# SAFETY ALERT

## Servo Tab Spring

### SA-SECS-CTSW-02

Technical Advice No. 12e  
 November 1<sup>st</sup>, 2006

Fig. 1

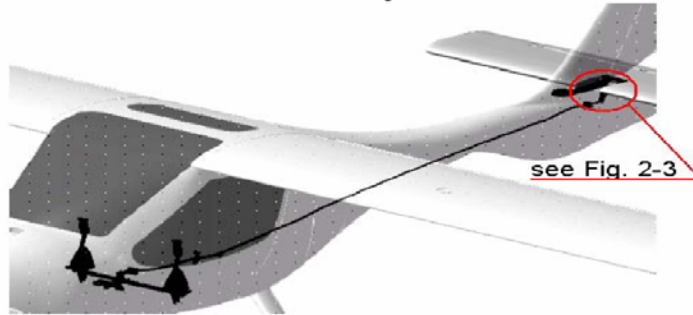
Action:  
 Flight Design is mandating a modification of the trim system on the affected aircraft that consists of replacing the original spring and associated spacer and washer with a new spring and telescopic spring guide assembly (Fig. 1)

Fig. 2 (Old)

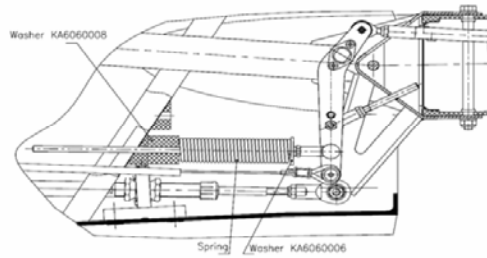
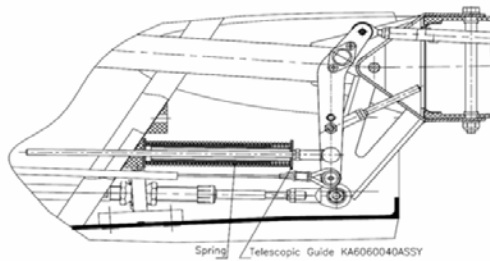
It was found that the anti-servo tab spring could, *under extreme conditions*, cause a sudden change in trim force pressure. This could result in a sudden pitching down movement of the aircraft that is most pronounced as Vne is reached or exceeded.

- Important:
- A. The new spring is longer than the original (37 (Fig 3) windings instead of 35 windings). The original one is too short and must not be used.(Fig 2)
  - B. The movement of the original, shorter spring is limited at one end by a plastic spacer (KA6060008) and at the other end by a washer (KA6060006) (Fig 2). These parts are also not reused.
  - C. When mounting, the gliding surfaces of the telescope and the surfaces contacting with the spring have to be lubricated by use of Aeroshell Grease 6 or equivalent, to support frictionless operation.
1. Mount the stabilizer in accordance with the Maintenance Manual and check for correct operation.
  2. Tag the original spring with the aircraft serial number and return to Flight Design.
